NOPOWER, V_{On_PD} , and V_{Off_PD} v120

This comment addresses r01-450, 449, 347, 451, 348, 349, 452, 227, 314, 353, and 238.

Figure 145–26—Single-signature PD state diagram (continued)

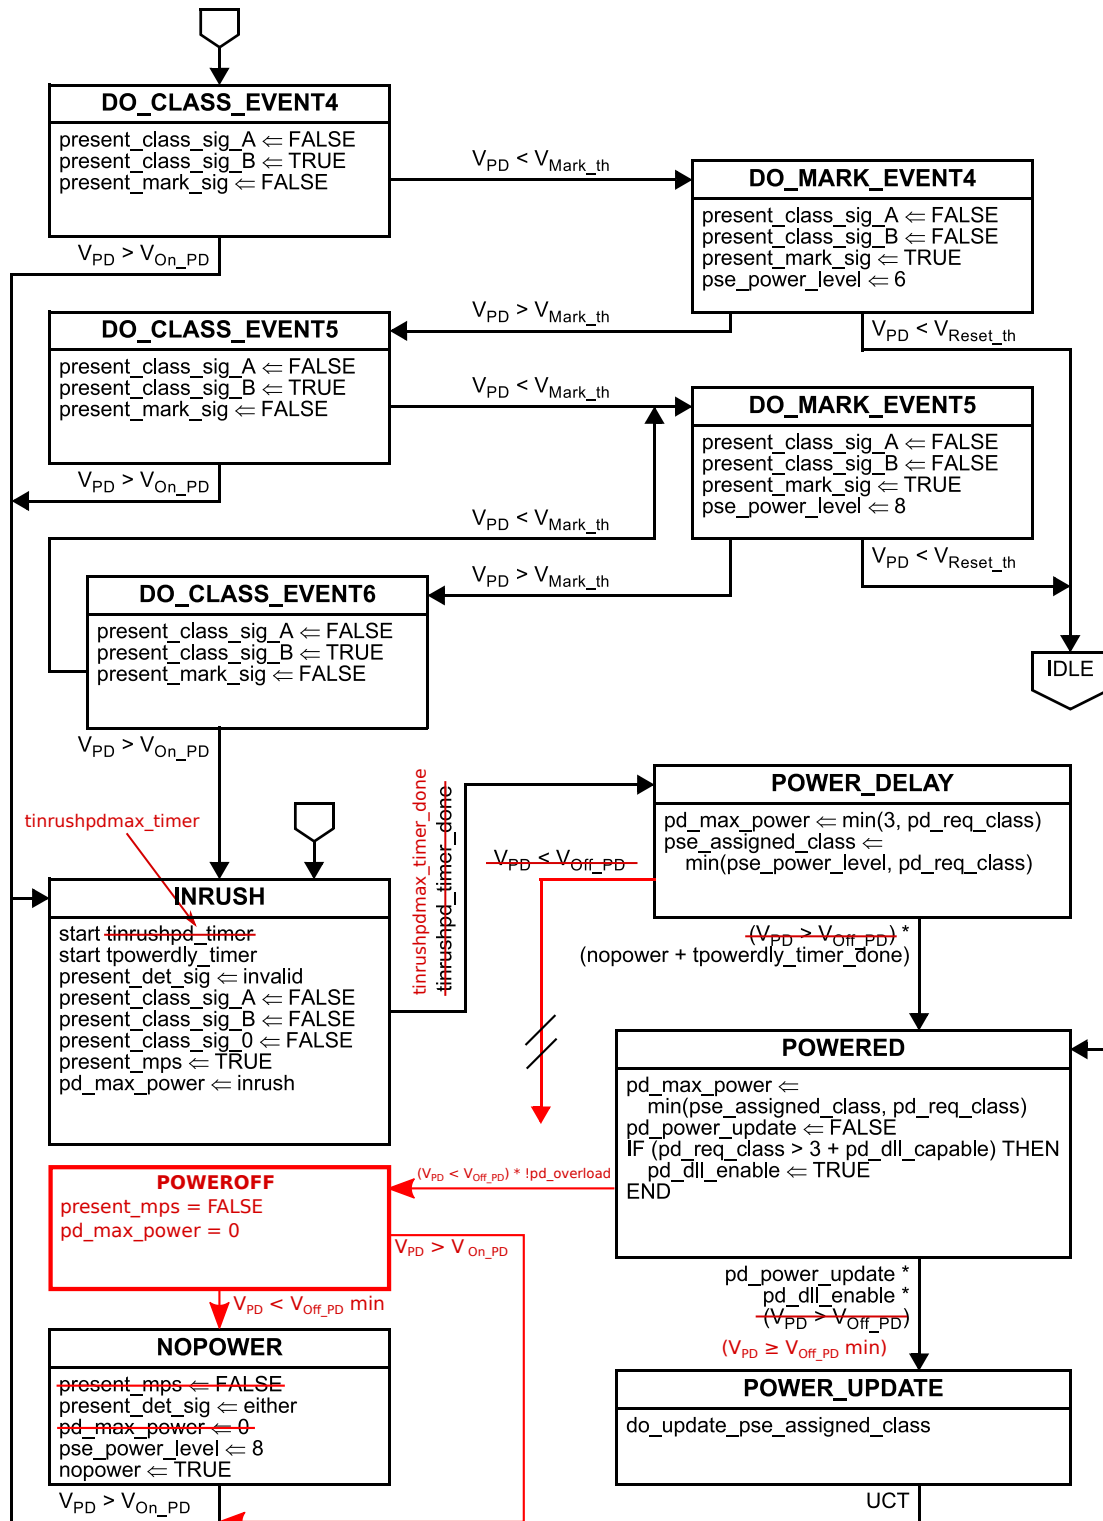
The state diagram implements this turning off of the PD with the NOPOWER state. Because the state diagram reacts instantaneously, depending on the value of V_{Off_PD} , it can happen that peak power draw, or a transient event causes the PD to transition to NOPOWER. Because NOPOWER is also used to specify behavior for PDs that are intentionally drawn back into mark/class/ V_{Off_PD} range, a conflict arises, because a pass through the NOPOWER state allows the PD to change its class event counter.

Another way to make an unwarranted pass through NOPOWER is for the PD to intentionally transition from INRUSH to POWER_DELAY before V_{PD} is in the V_{Port_PD-2P} range. This must also be prevented.

- the PD state diagram is forced to spend precisely 50 msin INRUSH (the state, not the condition).
- the entry logic into NOPOWER is changed to be $V_{PD} < V_{Off_PD}$ min.
- Add requirement that states a PD can't turn off due to compliant peak power draw or transients.

Change Figure 145–26 as follows:

Figure 145–28—Dual-signature PD state diagram (continued)

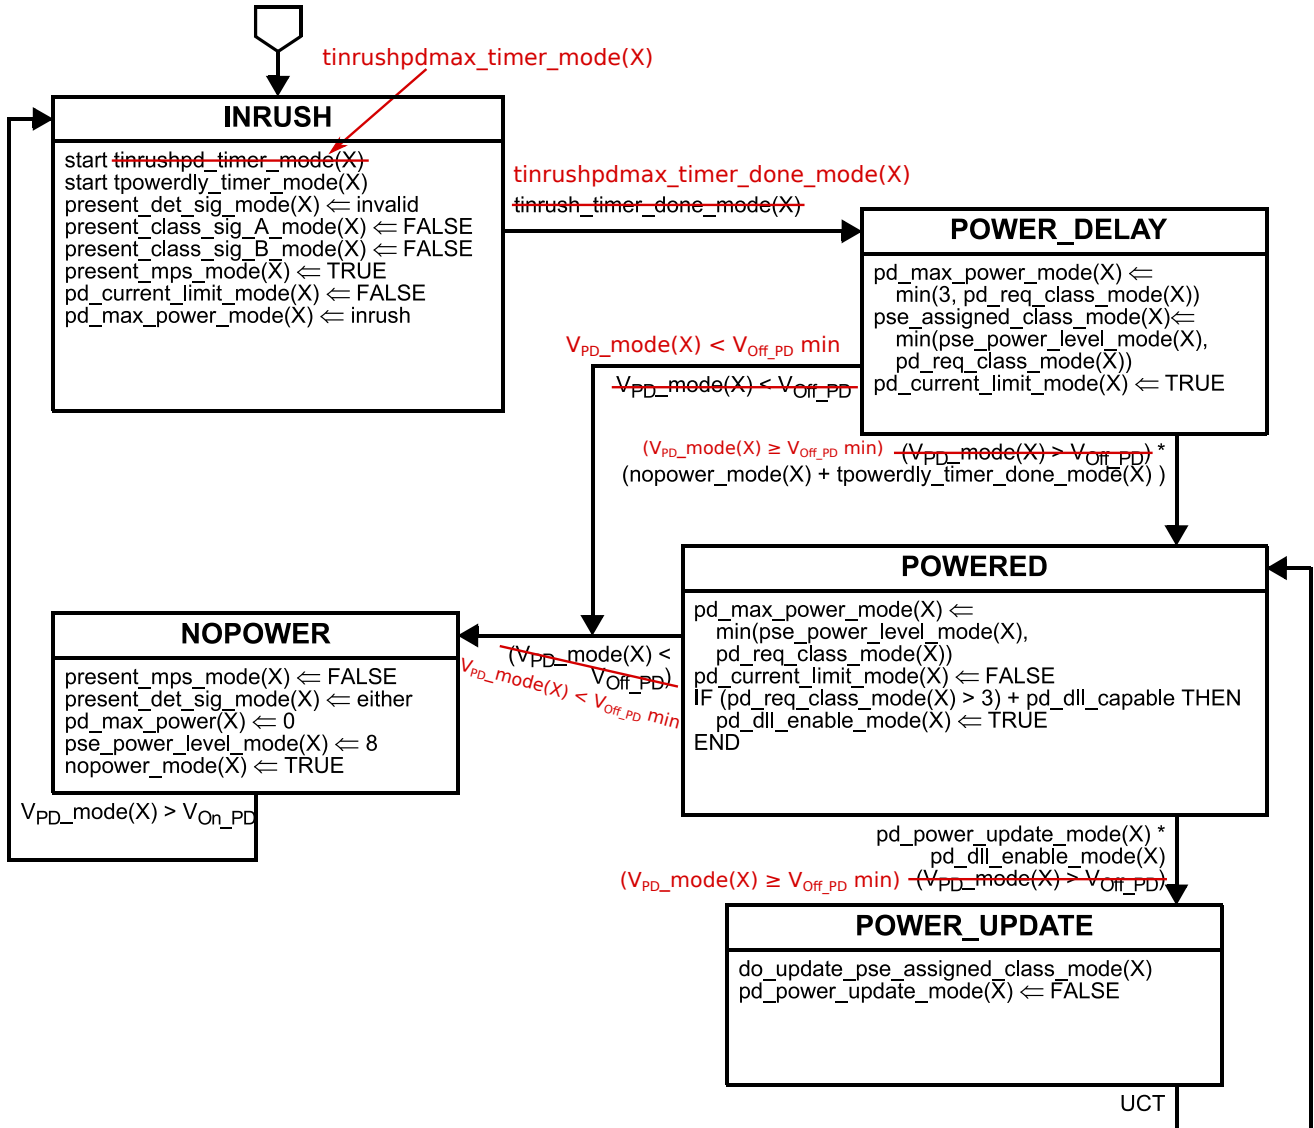
Change Figure 145–26 as follows:
